RE: Comments of March 21, 2005 APPLICATION: NB5-MB-49-HP YDI Wireless

WLL Project: 8441

Plot 1: Channel power with RBW=300kHz and VBW=3MHz; sweep time 50 ms Plot 2: Channel power with RBW=300kHz and VBW=3MHz; sweep time 50 seconds Plot 3: Channel power with RBW=300kHz and VBW=300kHz; sweep time 50 ms

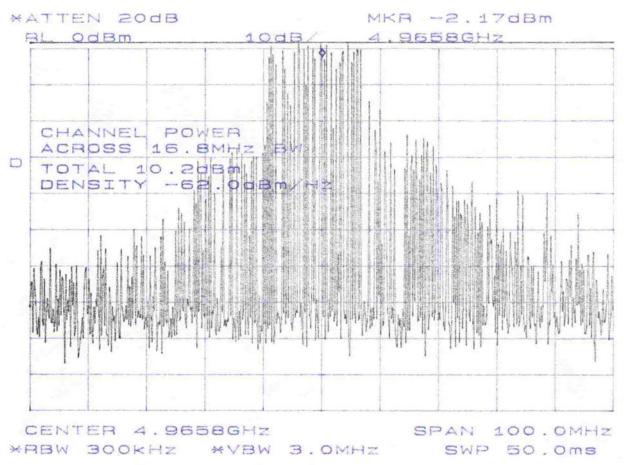
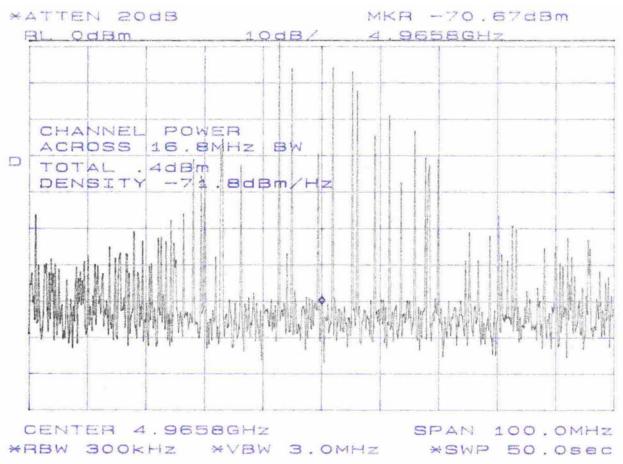
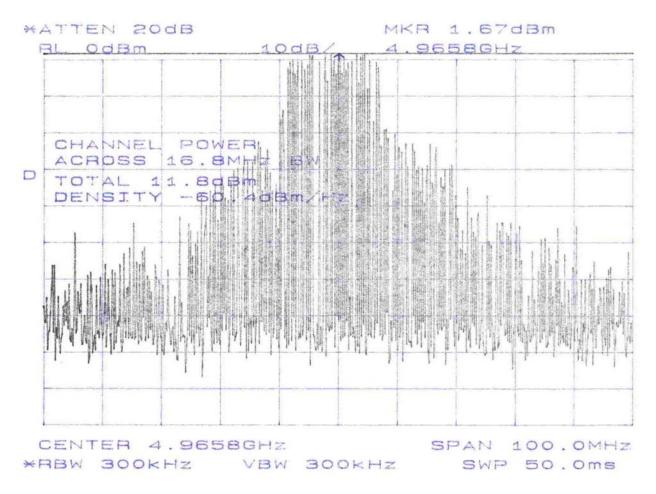
2.) I accept your test method for using the spectrum analyzer RMS detection function of this complex OFDM signal. However, I still have some concerns. Using the instrument manufacturer's explanation, the RMS value is computed for each "bucket" within the trace and then algebraically summed together. Looking at your plot, we do not have a smooth, symmetrical emission; we have a "lumpy" emission characteristic of multi carrier OFDM signals. I would like to know if the measured RMS values are affected by both sweep time and RBW settings. Moreover, using the standard 1% rule, a RBW less than 16.5MHz/100 usually should not be used unless additional explanation is provided. My preference is to know if this RMS measurement would be effected by an RBW of 300KHzor more and a sweep time greater than 50 seconds. Best accuracy is also obtained when the emission is near the top of the reference level due to errors in the log amp. Kindly help me understand the RMS detection function of this instrument. In addition, please confirm that the measurement was made over a "continuous interval" without any periods of "Tx off". Kindly refer to 90.1215(b).

R. Additional plots have been taken. The "lumpy" emission is characteristic of the SAMPLE mode that the analyzer needs to be in to take the correct rms measurement (as directed in the User's Manual for the instrument). MAX HOLDing the signal places it back into Peak mode.

Three plots are provided; the reference level has been adjusted to bring the emission to the top of the screen. In summary, the sweep time affects the channel power a great deal; thus, the channel power is reported with the fastest sweep time. The channel power is nominally the same between this re-measured data and the previously-reported values (10.8dBm vs 10.2dBm).

PLOT #1: Channel power with RBW=300kHz and VBW=3MHz; sweep time 50 ms

Plot 2: Channel power with RBW=300kHz and VBW=3MHz; sweep time 50 seconds

Plot 3: Channel power with RBW=300kHz and VBW=300kHz; sweep time 50 ms
